Access Compliance Report Public Rights-of-Way (Curb Ramps)

Main Street: SIERRA_ALTA_DR Cross Street: WOODLAWN_AVE Location: NE

ADA ID: RPAT211013085523 Ramp Type: Type 1 - Perpendicular Diagonal Initial Pass/Fail: Pass Overall Compliance: No Severity Score: 5

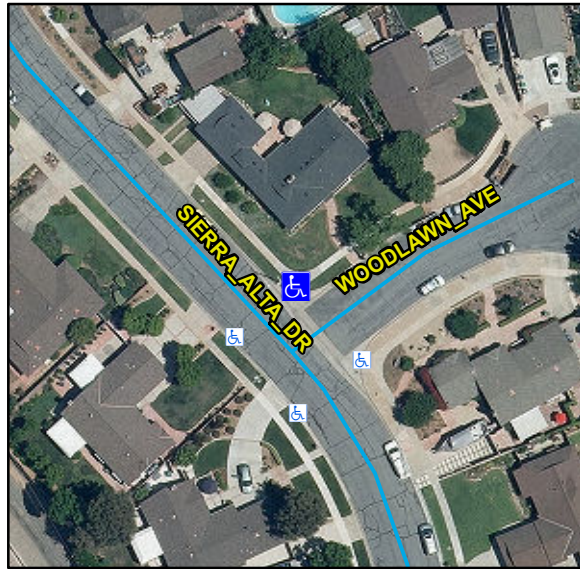
Remove & Replace Curb Ramp With Two New Directional Ramps or Equivalent. Remove & Replace Gutter.

R304.2.2, R304.2.1, R304.5.4, STD 1115

Compliance	Description	Data	Compliance	Description	Data
N/A	Ramp Length (in)	75	N/A	Flare Type LT	
Yes	Ramp Width (in)	50			Sloped
Yes	Ramp Run Slope (%)	7.3	N/A	Flare Slope LT (%)	3.2
Yes	Ramp Cross Slope (%)	0.6	N/A	Flare Traversable LT	No
N/A	Landing Present	Yes	N/A	Flare Type RT	
N/A	Landing Length (in)	48			Sloped
Yes	Landing Width (in)	51	N/A	Flare Slope RT (%)	5.4
Yes	Landing Run Slope (%)	1.5	N/A	Flare Traversable RT	No
Yes	Landing Cross Slope (%)	0.8	Yes	DWS Provided	Yes
N/A	Landing Movement Obstructed?	Yes	Yes	DWS Contrast	Yes
	Landing Movement Type	Curb	Yes	DWS Length (in)	36
N/A	Landing Shared	No	Yes	DWS Full Width	Yes
N/A	Clear Space	Yes	Yes	DWS Offset Left (in)	0
N/A	Clear Space To Crosswalk (in)	48	Yes	DWS Offset Right (in)	N/A
N/A	Marked Crosswalk 1	No	N/A	Marked Crosswalk 2	No
	Crossing 1 Direction	W		Crossing 2 Direction	S
	Marked Crosswalk 1 Width (in)	N/A		Marked Crosswalk 2 Width (in)	N/A

N/A	Ramp Inside Crosswalk 1	N/A	Yes	Ramp Inside Crosswalk 2	N/A
	Crossing 1 Slope (%)	4.1		Crossing 2 Slope (%)	2.7
	Crossing 1 Cross Slope (%)	1		Crossing 2 Cross Slope (%)	8.8
Yes	Gutter Ponding	No	No	Curb Slope	5.8
Yes	Gutter Lip Height (in)	0		Road Run Slope (%)	5.3
No	Gutter Run Slope (%)	7.1		Road Cross Slope (%)	8.4
Yes	Gutter Cross Slope (%)	2.6			
Yes	Overall Surface Condition: Acceptable		Yes	Perp Joint Present	Yes
	Cross Gutter Present?	Yes		Spandrel Present?	Yes
	Replace Cross Gutter?	No		Replace Spandrel?	No
